Cambridge Cycling Campaign

Subject: Application S/3440/18/OL

Case Officer Mike Huntington
South Cambridgeshire Hall
Cambourne Business Park
Cambourne CB23 6EA

October 7, 2018

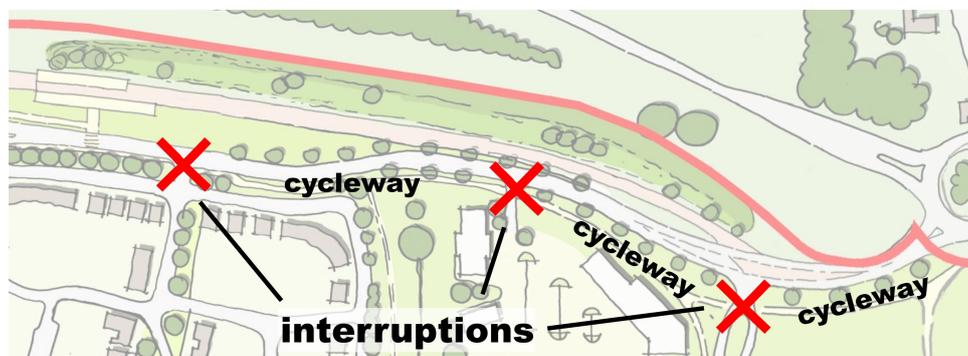
Yet, when we examine the documents for this application, we find many cases where walkways and cycleways are interrupted and give way to motor traffic carriageways. For example, in drawing 'CP-BOURNACCESS(WESTERN).1' we see that cycleways are interrupted in one case by the primary road and in another case by a minor side road.

In the Illustrative Master Plan there are numerous cases of minor side roads interrupting footways and cycleways, giving priority to motor traffic over people walking and cycling. It also appears to be the case that all of the off-road walking and cycling routes are interrupted every time they encounter roads. Further confusion is caused because some documents refer to these off-road pathways as cycle routes, while some others refer to them simply as footpaths (e.g. on page 114 of the Design and Access Statement the diagram refers to a 'Footpath connecting the outdoor sports' while indicating one of the walking and cycling links from the parameter plan).

Even the 'strategic cycleway' is broken: from the eastern edge of the site the strategic cycleway is interrupted twice by minor roads before it disappears entirely at a third minor road; all of this happens before it even reaches the eastern bus halt.

Cycleways in green are interrupted by roads at the red Xs.

The strategic cycleway is interrupted three times in this section alone.

Figure 3.13
Filtered permeability in Houten, the Netherlands

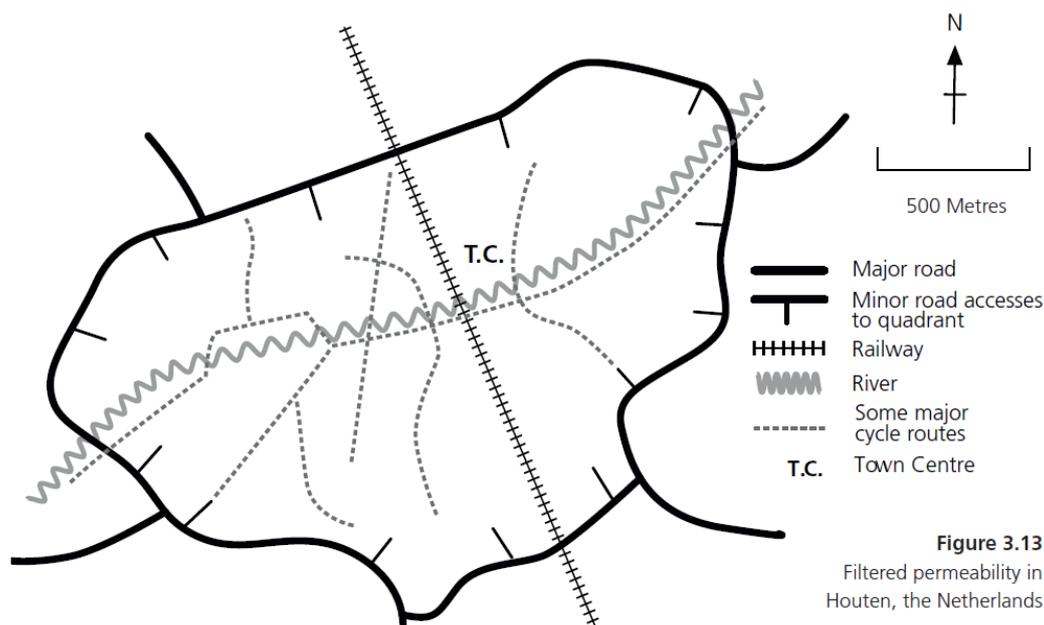
Our recommendation for this (and other developments) is to adopt the lessons of Houten in the Netherlands by designing a perimeter roadway that keeps most motor traffic to the exterior of the site. Within the perimeter, walking and cycling routes should be protected from and have priority over motor traffic. The interior should be divided into sections with boundaries that prevent private motor traffic from rat-running, while remaining fully permeable to walking, cycling, emergency vehicles and where applicable, public transport. Private motor traffic should be directed outwards to the perimeter roadway, and around the outside of the built-up area. This ensures that walking, cycling and public transport enjoy a grid of simple and direct routes and become the preferable option for local transport, while internal motor traffic congestion is minimised. Bourn Airfield does not have a railway like Houten, but the dedicated strategic bus route can serve a similar purpose. Please see the ITDP study¹ of Houten for more information.

We do see some evidence of partitioning within the current Illustrative Master Plan, in parts where open spaces and parks separate the built-up areas. However this proposed design is not like Houten because (a) the primary road 'ring' of this application is too close to the centre of the site, which makes internal motor traffic trips more direct and attractive, and (b) the grid of walking/cycling routes are frequently interrupted, indirect, often socially isolated, pushed outwards, and sometimes missing entirely. Apart from the dedicated bus route, the applicants seem to be largely repeating the mistakes of Cambourne, a development that suffers from high car-dependency with very low levels of walking and cycling.

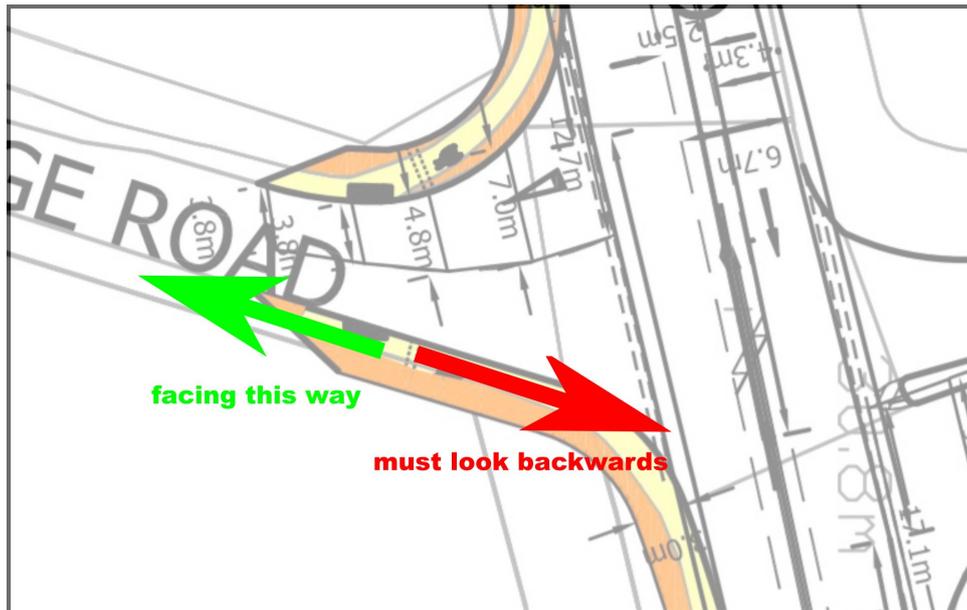
Outside the site, we do not understand how the applicants have managed to examine the entire A1303/St Neots Road corridor and yet have proposed only one highly questionable 'improvement' to the so-called 'Cambridge Crossroads' junction at Coton. It is true that a signalised crossing of Madingley Road may well be appropriate here, however the geometries of the pathways as they cross both of the Cambridge Roads remain inappropriate for cycling. In particular, the crossing of Cambridge Road (Coton) requires a person cycling outbound to turn back 180 degrees in order to see any approaching vehicles while also keeping an eye in front, a contortion that is nearly impossible for many people. The existing conditions also require this, but currently most people riding on the A1303/St Neots Road route are coming from the Coton Path, avoiding the crossing in question. If the applicant intends more people to use this crossing then the geometry should be corrected in line with IAN 195/16 section 2.4.11.

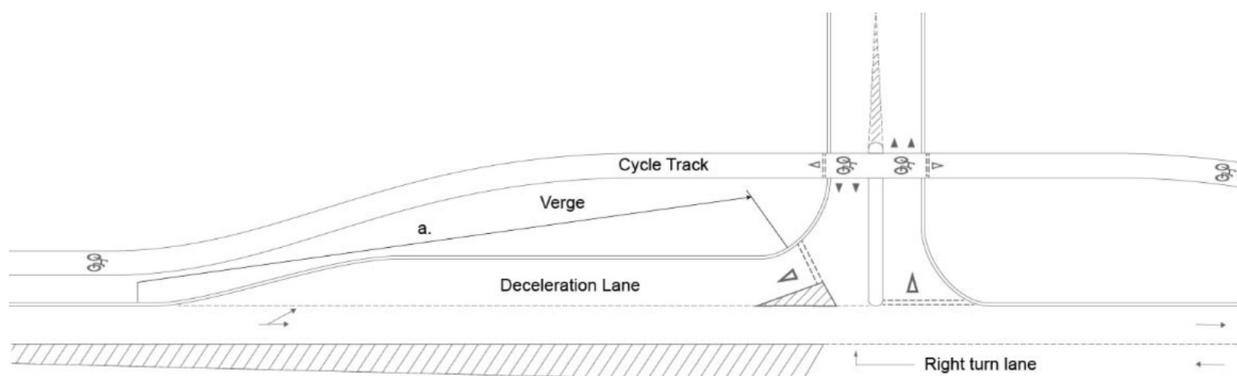
The safe use of the Cambridge Road (Coton) crossing requires a person to have eyes in back of their head.

Section 2.4.11 of IAN 195/16 describes a safe side-road crossing design.
